MEMORANDUM

To: Lia Obaid
Design Division

From: Matt Richards
Environmental Division

Subject: ENVIRONMENTAL BOUNDARIES AND MITIGATION DESIGN FOR:
Fayette County, Interstate 40 Interchange at State Route 222
P.E. 24001-0147-44 PIN 114219.00

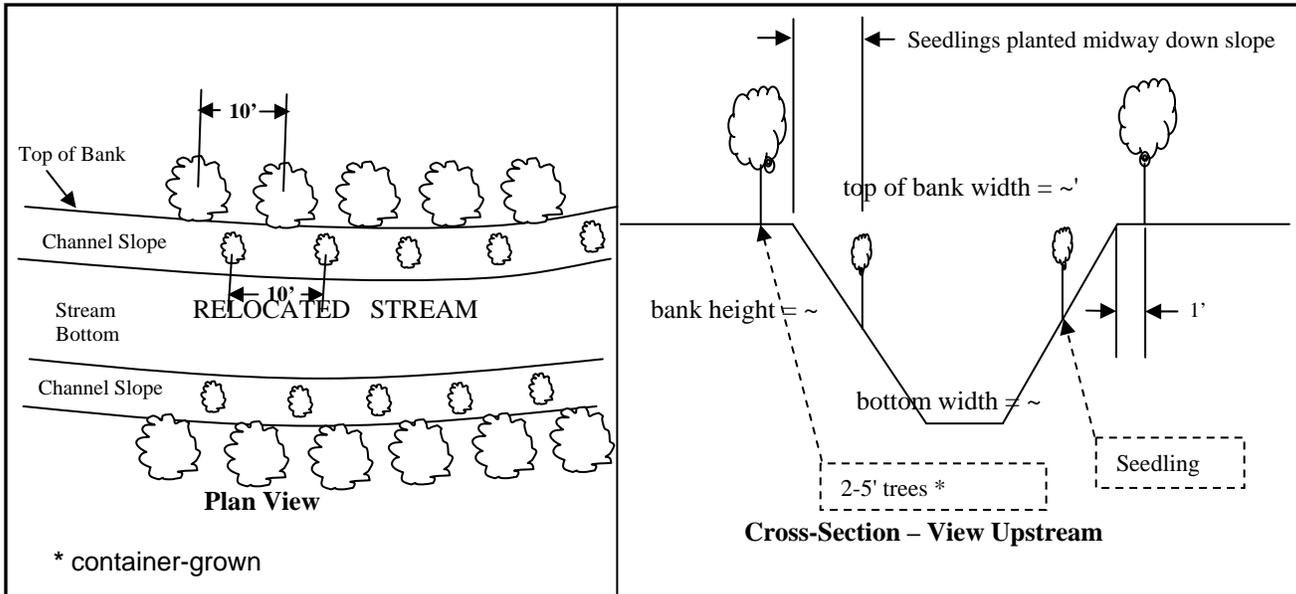
Station	Map label	Attachments: Marked-up plans sheet (A); notes (B); mitigation plan (C) attached	Calculate permanent & temporary wetland impacts & provide to (name of regional biologist) and John Hewitt ("X")	Apply "standard" stream relocation configuration & instructions ("X")	Survey boundaries as flagged in field ("X")	General notes and/or specific changes requested
None Provided	STR-1	A, B, C		X		Unknown if STR-1 will require relocation or culvert extension. In-lieu fee payment required if culvert exceeds 200'. Standard stream relocation (attached) applies if a required relocation exceeds 50' in length.
None Provided	WTL-1	A, B, C	X		X	Unknown if WTL-1 will be impacted. If permanent project wetland impacts exceed 0.10 acres, mitigation will be required at 2:1 ratio in the Hatchie Mitigation Bank. Temporary wetland impact instructions are attached if necessary.
None Provided	SPG-1	A				Unknown if SPG-1 will be impacted. A spring box will be required to maintain flow to STR-1 if fill will cover SPG-1.

None Provided	WTL-2	A B, C	X		X	Unknown if WTL-1 will be impacted. If permanent project wetland impacts exceed 0.10 acres, mitigation will be required at 2:1 ratio in the Hatchie Mitigation Bank. Temporary wetland impact instructions are attached if necessary.
None Provided	WTL-3	A, B, C	X		X	Unknown if WTL-1 will be impacted. If permanent project wetland impacts exceed 0.10 acres, mitigation will be required at 2:1 ratio in the Hatchie Mitigation Bank. Temporary wetland impact instructions are attached if necessary.
